Executive Director's Recommendation

Commission Meeting: May 3, 2018

PROJECT New Security Fence Joint Base Myer – Henderson Hall Arlington, Virginia	NCPC FILE NUMBER 7925
SUBMITTED BY United States Department of Defense Department of the Army	NCPC MAP FILE NUMBER 1.61(38.40)44728
REVIEW AUTHORITY Federal Projects in the Environs per 40 U.S.C. § 8722(b)(1)	APPLICANT'S REQUEST Approval of preliminary site development plans
	PROPOSED ACTION Approval of preliminary site development plans with comments
	ACTION ITEM TYPE Staff Presentation

VIEW 12A – Closeup of OPC Gate from Meigs Dr

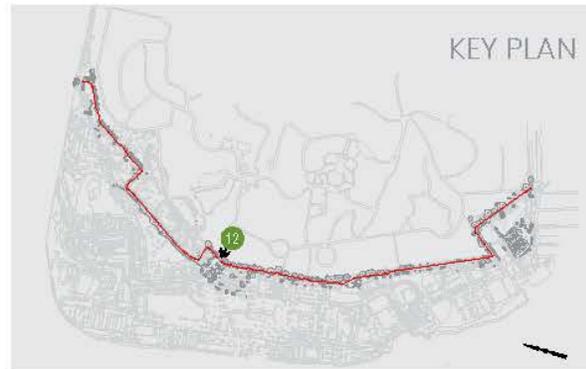
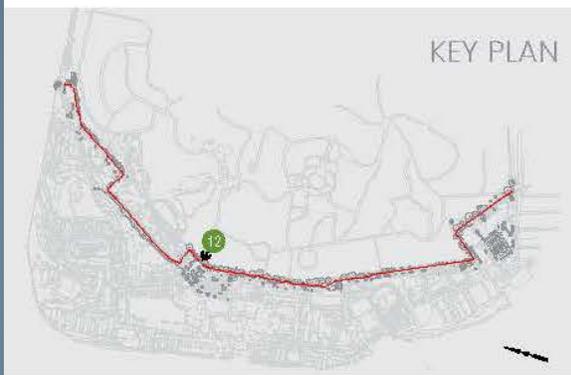
Finds that the proposed slide arm security gate will have a negative impact on views of the historic gate, wall and piers in the closed position; however, this will only occur at night.

Finds that while the proposed slide arm security gate has a negative impact on views of the historic gate, wall and piers when closed, the impacts are significantly reduced when open.

Supports the Army's proposed slide arm security gate at the Old Post Chapel Entrance, recognizing that bollards are an aesthetically better option, however, the slide arm security gate provides the reliability needed for this public entrance.

VIEW 16 – Selfridge Gate

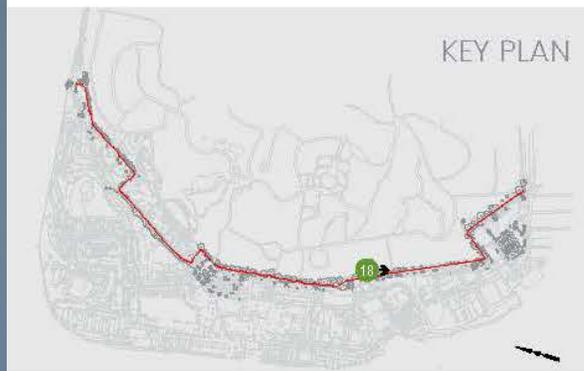
Finds that the proposed gate design for both entrances is not a clearly defined gateway similar to the entrance in the historic wall. As proposed, there is no differentiation between the security fence and the gate.

Requests the Army consider the use of piers, posts or other elements to clearly frame the gates, and explore additional design details that will help differentiate the gates from the proposed fence.

VIEW 21 – Hobson Gate

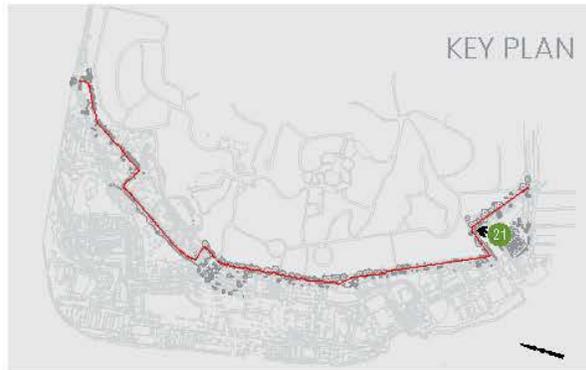
Notes that the Hobson entrance is permanently closed and the security fence will continue without a gate at this entrance.

Supports the continuous fence at this entrance because the area in front of the gate will be landscaped.
